- 3. Caribou Crossing Subdivision; KPB File 2024-054
Edge Survey & Design, LLC / Kenai Peninsula Borough
Location: Heather Avenue & Maudi Drive
Kalifornsky Area**

**ITEM #3 - PRELIMINARY PLAT
CARIBOU CROSSING SUBDIVISION**

KPB File No.	2024-054
Plat Committee Meeting:	June 10, 2024
Applicant / Owner:	Kenia Peninsula Borough
Surveyor:	James Young / Edge Survey and Design Inc
General Location:	Northeast end of Kalifornsky area near high end of Kenai River bow. Kalifornsky APC

STAFF REPORT

CARIBOU CROSSING SUBDIVISION

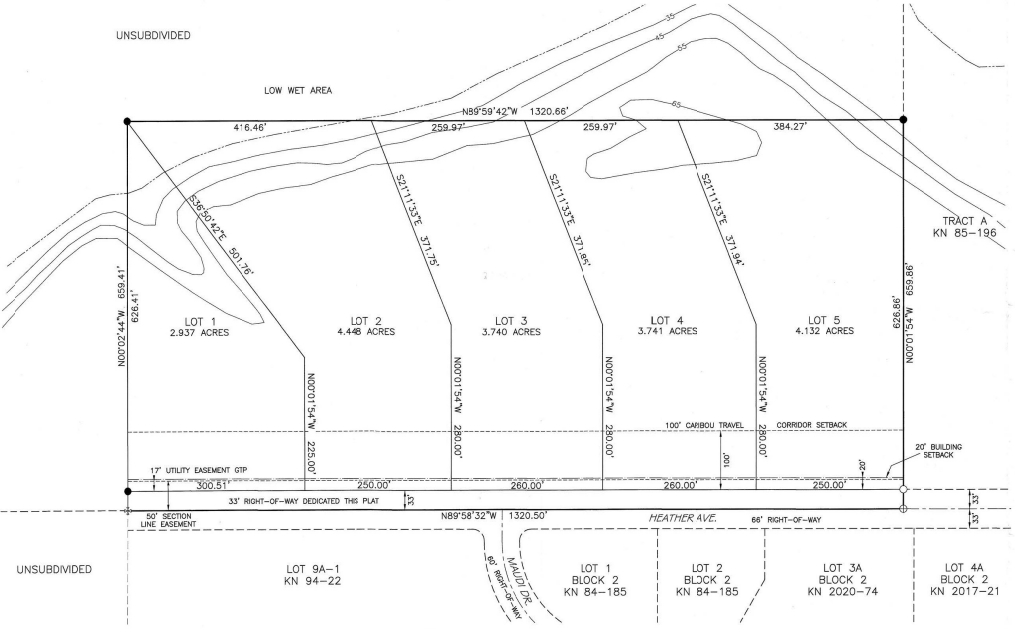
The subdivision is affected by a 50 foot section line easement on the south line of the subdivision as noted. It is recommended to move the note to a location and flag to make it easier to identify.

There are steep areas shown on the plat by the contours but they are not flagged as such. The contours, when analyzed, show a steepness of 37% in proposed Lot 2 and 30 % in the corner of proposed Lot 5. **Staff recommends:** for the final submittal, the contours be removed and slopes of 20% grade or more be identified.

There is a drainage ravine shown on Lot 1 indicated by the contours. **Staff recommends:** the surveyor identify the drainage area on the final in a form easily understood to be an unbuildable drain area.

KWF Wetlands Assessment shows lakebed and drainageway appear across the proposed parcels of the plat. These areas should be noted and identified on the drawing of the final plat. the appropriate plat note is present on the drawing at #3 and should remain for the final plat submittal.

The subdivision is located in a FEMA identified flood zone of Zone C and D. Per 20.30.280.D., the Flood Hazard Notice needs to be added to the plat as a plat note or a general notation. The note should include the FIRM Panel number and Zone the plat is within. **Staff recommends:** the Plat Committee concur plat note #3 to remain and the surveyor to add the Flood Hazard Notice to the plat.

The surveyor has indicated a 100' Caribou Travel Corridor Setback on the plat. **Staff recommends:** the surveyor either identify the source of the setback or if being dedicated by this plat, label it as "dedicated this plat".

Add label to Kenai Spur Highway in the vicinity map.
Modify the KPB File No to 2024-054.
Lot 4A to the southeast needs the Block 2 removed

- B. North point;
Staff recommendation:
Add a “N” to the arrow for north designation

- C. The location, width, and name of existing or platted streets and public ways, railroad rights-of-way, and other important features such as section lines or political subdivisions or municipal corporation boundaries abutting the subdivision;
Staff recommendation:
Add 33’ section line easement to the east on both sides of section line
Add 33’ section line to the south of property
Add 50’ section line easements to the west on both sides of the section line
Move the 50’ section line easement note to above into the subdivision for better notation.
Label 33’ right of way on the south part of Heather Ave and add total to the 66’ right-of-way

- H. Approximate locations of low wet areas, areas subject to inundation, areas subject to flooding or storm water overflow, and the line of ordinary high water. This information may be provided on an additional sheet if showing these areas causes the preliminary plat to appear cluttered and/or difficult to read;
Staff recommendation:
KWF Wetlands Assessment lakebed and drainageway should be noted and identified on the plat.

- J. Block and lot numbering per KPB 20.60.140, approximate dimensions and total numbers of proposed lots;
Staff recommendation:
Fix overstrikes on dimensions on interior with the corridor setback line.

- M. Approximate locations of slopes over 20 percent in grade and if contours are shown, the areas of the contours that exceed 20 percent grade shall be clearly labeled as such;
Staff recommendation:
Steep areas need identified.

- A. The planning commission may require easements it determines necessary for the benefit of the public. Such easements include, but are not limited to, lateral support (slope) easements, drainage easements for ditching or protection of a drainage, and utility easements. Required easements do not need to be for road purposes.
Label source of 100' Caribou Travel Corridor Setback or if dedicated this plat, label so.

Add Certificate of Acceptance for Heather Ave
